City of **HOBART**

APPLICATION UNDER HOBART INTERIM PLANNING SCHEME 2015

Type of Report:	Committee
Committee:	31 October 2016
Expiry Date:	3 December 2016
Application No:	PLN-16-856
Address:	214 MELVILLE STREET , WEST HOBART
Applicant:	Dean Kelly (M2architecture) 25 Arthur Street
Proposal:	Partial Demolition, Extensions and Alterations and Additional Dwelling
Representations:	Three (3)
Performance criteria:	Residential density for multiple dwellings, setbacks and building envelope, site coverage and private open space, historic heritage code.

Figure 2: The proposed site plan.

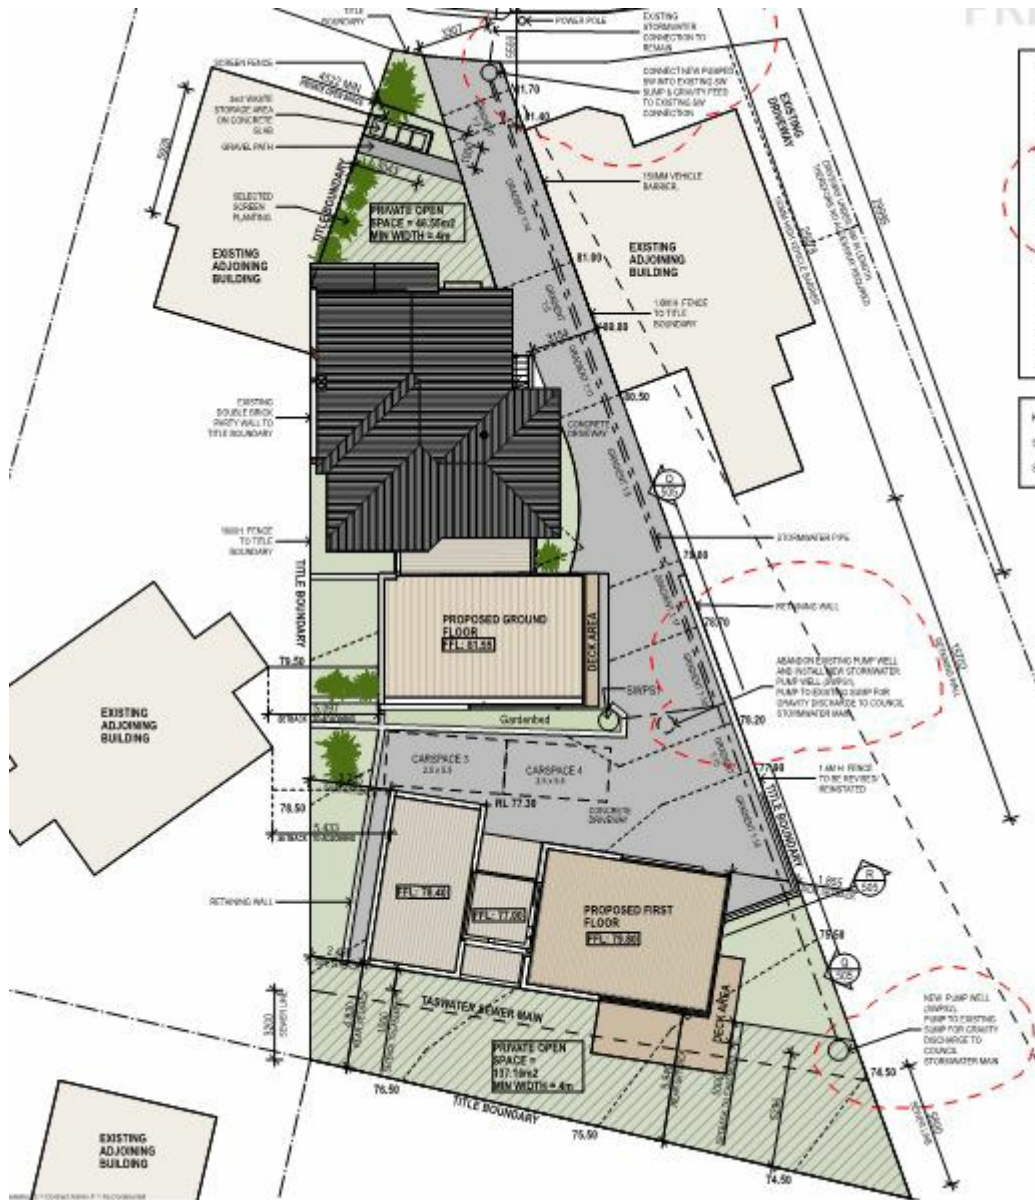
6.7.1 A relatively small section of the development's south eastern elevation protrudes outside of the building envelope that defines acceptable height and bulk. The deck on the upper level and the roof edge on the upper level are also both slightly outside of the envelope.

- 6.7.5 At 9:00am on the shortest day of the year, there will be some overshadowing of the units to the west (216-220 Melville Street) and south west (249 Bathurst Street). By midday, the overshadowing to 216-220 Melville Street is to a small section of the property near the boundary shared with the subject site, with 249 Bathurst Street being clear of overshadowing. It should be noted that the closest dwelling on 216-220 Melville Street would already experience some overshadowing from the existing dwelling on the subject site.

- 6.7.6 In relation to the properties directly to the south (247 and 247A Bathurst Street), there will be some overshadowing to various parts of their rear yards at 9:00am, noon and 3:00pm. At midday, there would be some shadowing to the north western corner of the house at 247 Bathurst Street. By 3:00pm, this shadow will continue over the majority of their rear yard and pass over a small section of the north eastern corner of the house. By 3:00pm, the shadowing will also extend significantly and pass over other properties to the south east at 245, 243 and 241 Bathurst Street.

In this case, the degree of protrusion from the building envelope that is deemed to represent acceptable height and bulk is minor, being small sections of roof and deck on the southern elevation of the additional dwelling, and a very small section of roofing on the southeastern side of that dwelling. The degree of difference between the shadow cast by the proposed development compared with a development complying with the defined building envelope is unlikely to be discernible. As such, if a

Notwithstanding the submitted plans, the external brick chimneys to the main body of the existing dwelling must be retained as existing.
